[Docket No. 2002-SW-54-AD; Amendment 39-13087; AD 2003-05-11]

Airworthiness Directives; Bell Helicopter Textron Canada Model 407 Helicopters

2003-05-11 Bell Helicopter Textron

Figure 1. Correct cup washer direction, installation of

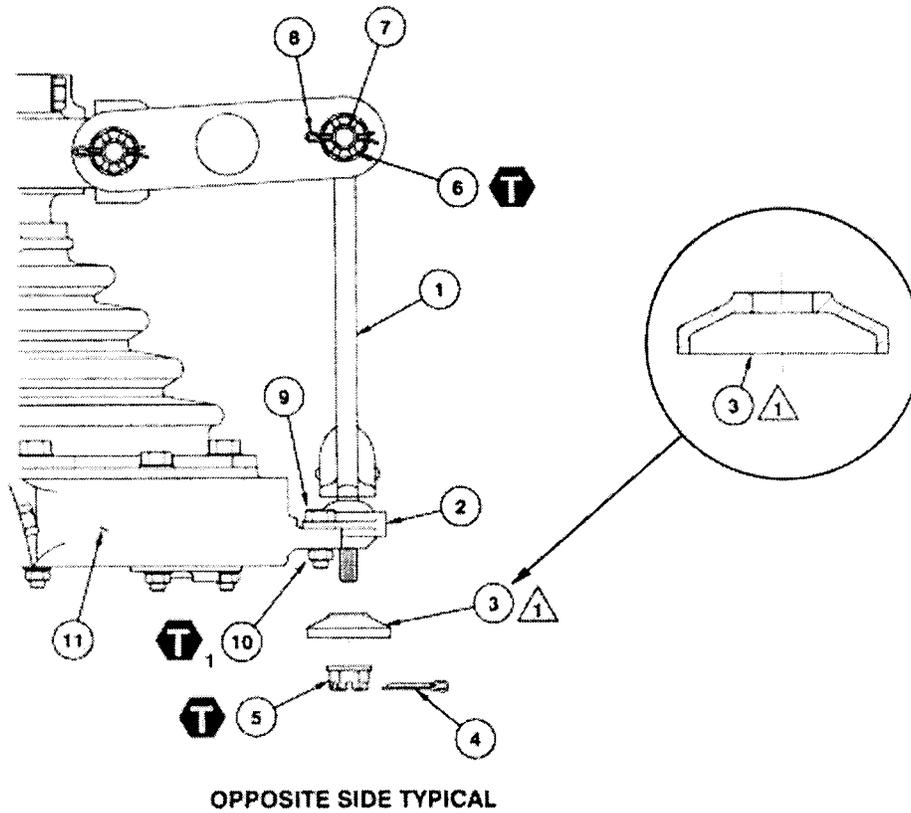
(a) Visually check both cup washers, part number (P/N) 406-010-412-101, for correct installation in accordance with Figure 1 of this AD. If both cup washers are installed correctly, no further action is required. This visual check may be performed by an owner/operator (pilot) holding at least a private pilot certificate, and must be entered into the aircraft records showing compliance with this paragraph in accordance with sections 43.11 and 91.417(a)(2)(v) of the Federal Aviation Regulations (14 CFR sections 43.11 and 91.417(a)(2)(v)). See the following Figure 1:

Note 2: In Part II, step 3.a. of the alert service bulletin, the swashplate is incorrectly referenced as item 10 of Figure 1. The reference should state item 11.

(b) If a cup washer is installed incorrectly, remove and replace the swashplate outer ring, each cup washer, bearing and liner, and drive link where the cup washer was installed incorrectly. Replace these parts in accordance with Part II of the Accomplishment Instructions in Bell Helicopter Textron Alert Service Bulletin No. 407-02-55, dated October 29, 2002.
